PECO Nuclear

10CFR50.59 Review for NCR PB 96-03414,  
Core Spray T-Box Cracks

Peach Bottom Atomic Power Station Unit 2  
Revision 0

PBAPS Unit 2  
Core Spray Tee-Box Az 120 Deg  
Left Side Angle Approx. 48 Deg.  
Right Side Angle Approx. 38 Deg.

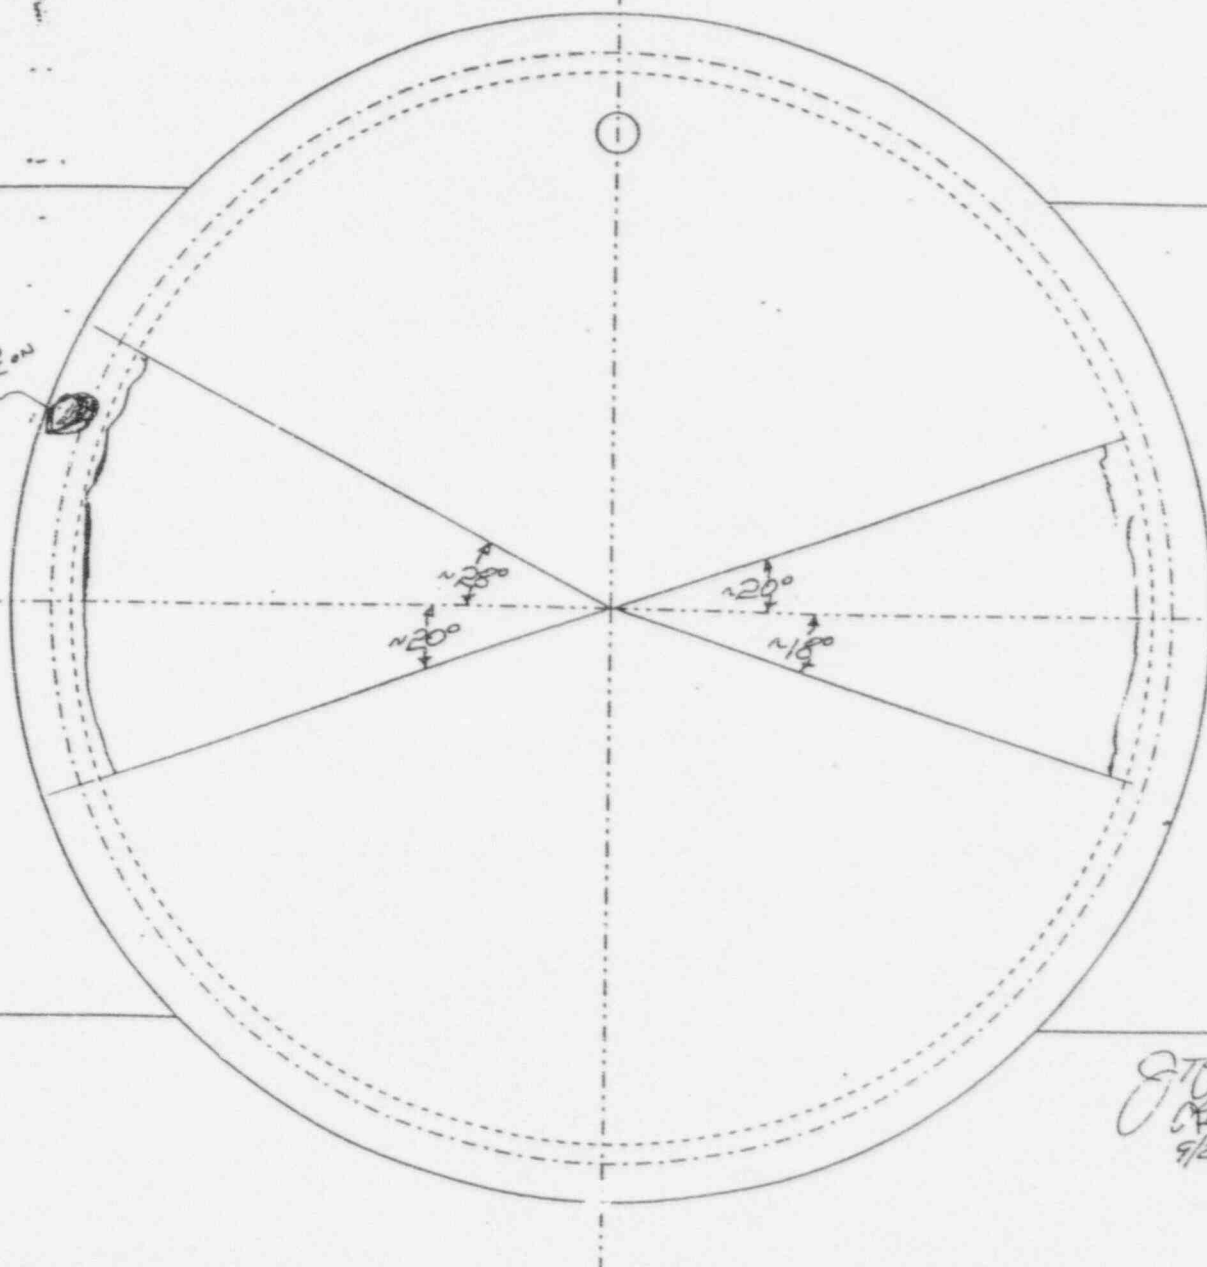
GRIND  
FILL ON  
WELD

VISUAL EXAM
